7.6 All Other Instrumentation Systems Required for Safety

The information in this section of the reference ABWR DCD, including all subsections, tables, and figures, is incorporated by reference with the following departures and supplements.

Table 7.6-4a Basic Configuration of a Typical Neutron Monitoring System Division

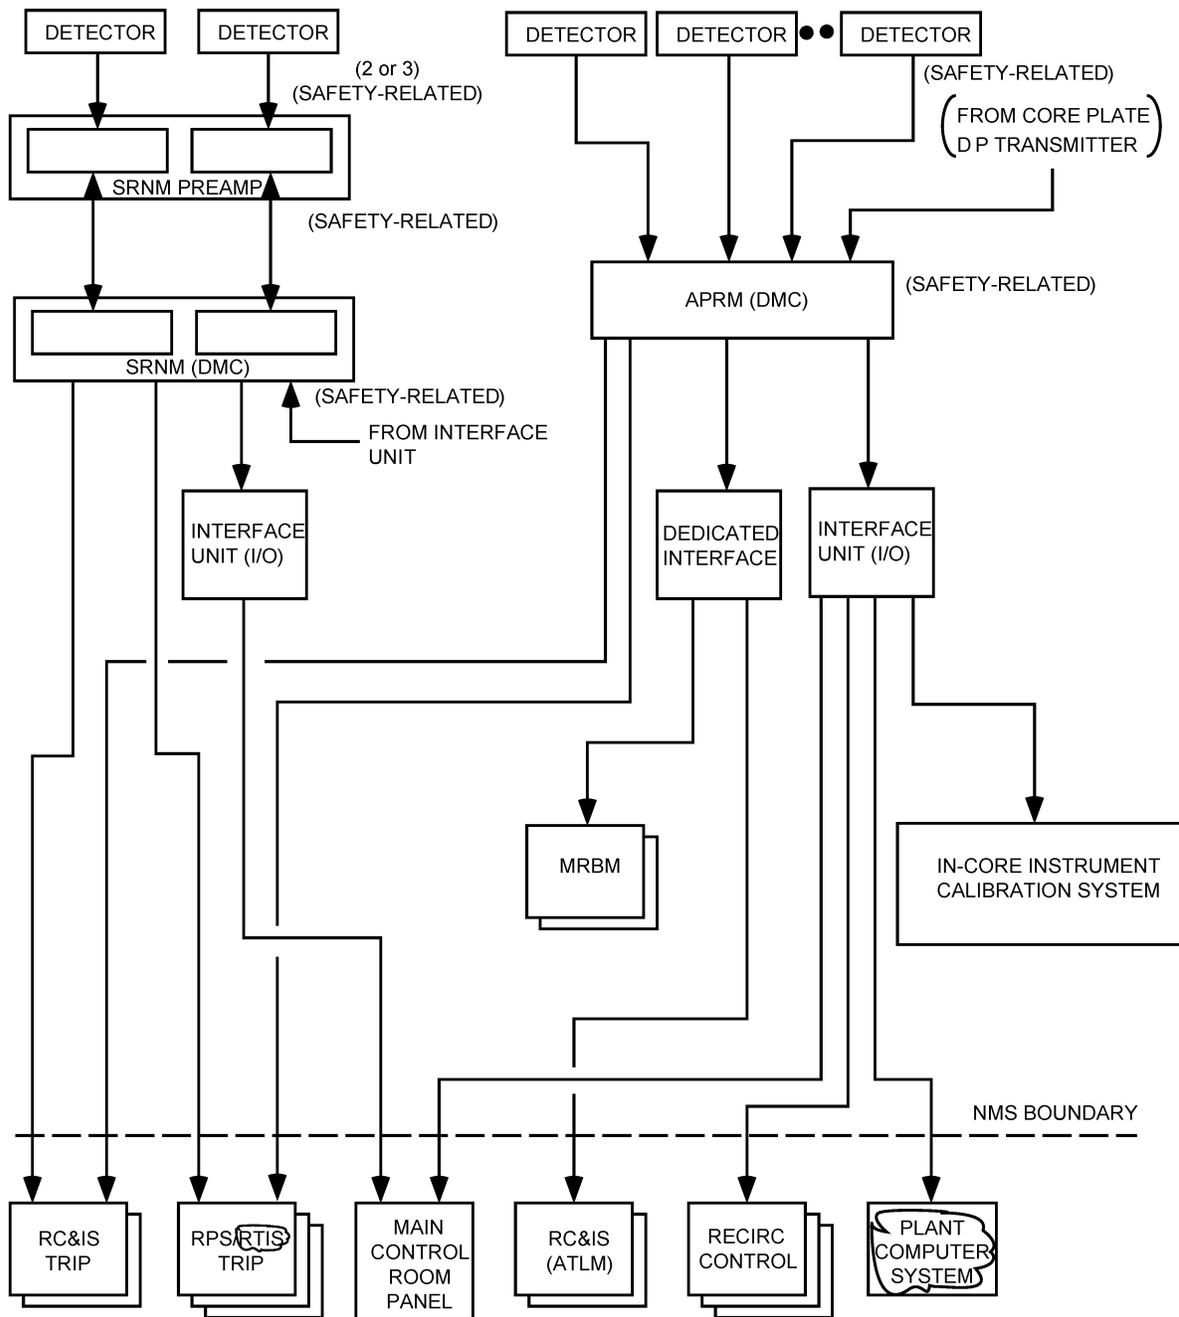
STD DEP T1 3.4-1 (Table 7.6-5 and Figures 7.6-1, 7.6-2, 7.6-4a)

The purpose of the Neutron Monitoring System (NMS) is to monitor power generation and, for the safety function part of the NMS, to provide trip signals to the Reactor Protection System (RPS) to initiate reactor scram under excessive neutron flux (and power) increase condition (high level) or neutron flux fast rising (short period) condition. The NMS also provides power information of operation and control of the reactor to the Plant Process Computer System (PCS) Functions (PCF) and the rod block monitor. A block diagram showing a typical NMS division is shown in Figure 7.6-4a. The operating ranges of the various detectors are shown in Figure 7.6-4b.

Figure 7.6-9 Instrumentation Location Definition for the Suppression Pool Temperature Monitoring System

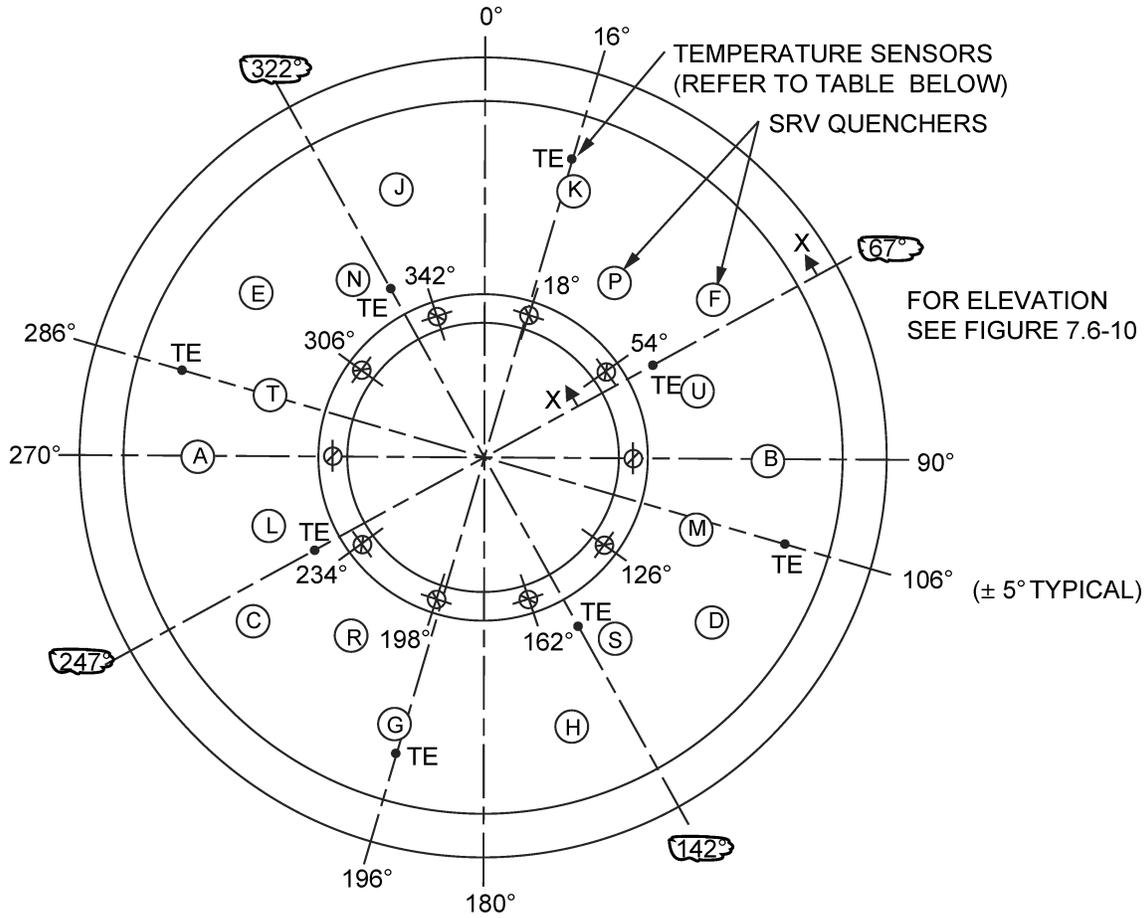
STD DEP 7.6-3 (Figures 7.6-9, 7.6-11, 7.6-12)

The SPTM System configuration is shown in Figures 7.6-9 and 7.6-10. There are eight temperature circumferential sensor locations (Figure 7.6-9), which are chosen based upon the following considerations:

- (2) Each SRV discharge line quencher is in direct sight of two sets of temperature sensors within 9 meters.

Figure 7.6-14 OPRM Logic

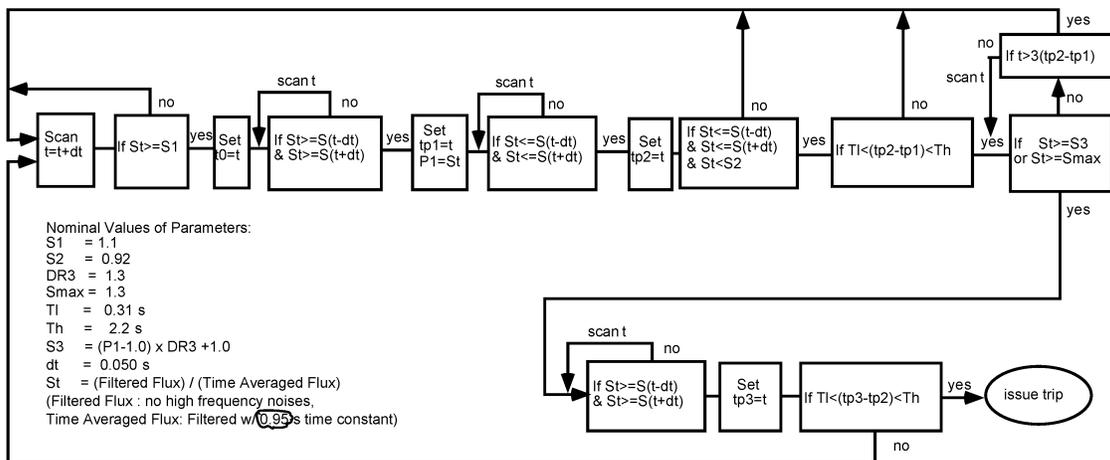
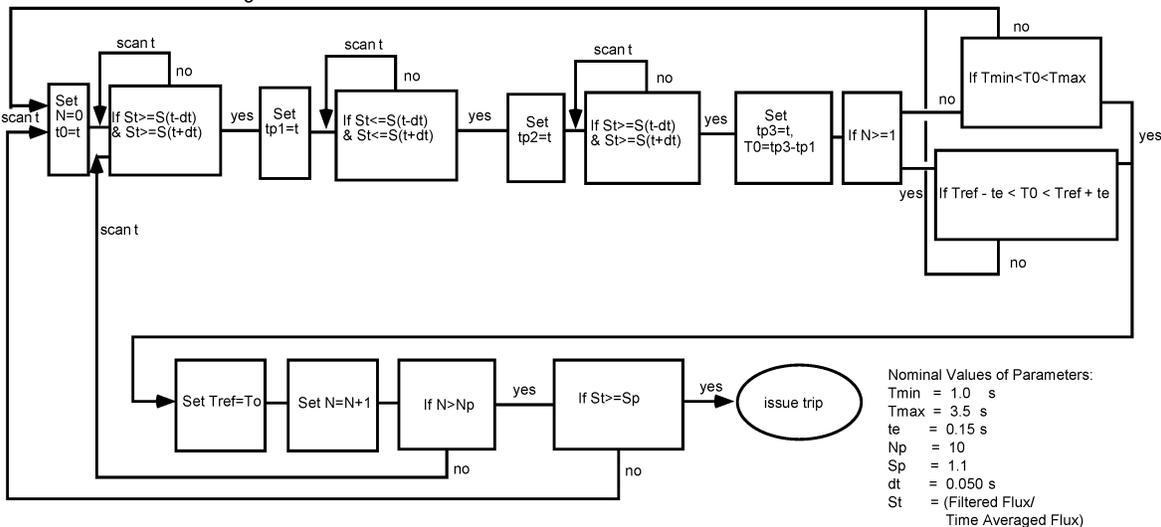
STD DEP 7.6-1 (Table 7.6-2 and Figures 7.6-2, 7.6-14)

For the OPRM trip function, the response signal of any one OPRM cell that satisfies the conditions and criteria of the trip algorithm will cause a trip of the associated OPRM channel. Figure 7.6-14 illustrates the trip algorithm logic. ~~The OPRM trip function does not have its own inoperative trip for insufficient number of total LPRM inputs in the channel. It follows the APRM's inoperative trip of insufficient number of LPRMs.~~ The OPRM function has its own inoperative trip when the channel has less than the required minimum operable cells, or there is an OPRM self-test fault, or the APRM instrument firmware/software timer has timed out, if there is a loss of power to the APRM instrument.

$T_{min} = 1$ s, $T_{max} = 3.5$ s, $\pm t_{error} = 0.15$ s **0.1s**, $N_P = 10$.
(For details see Figure 7.6-14).
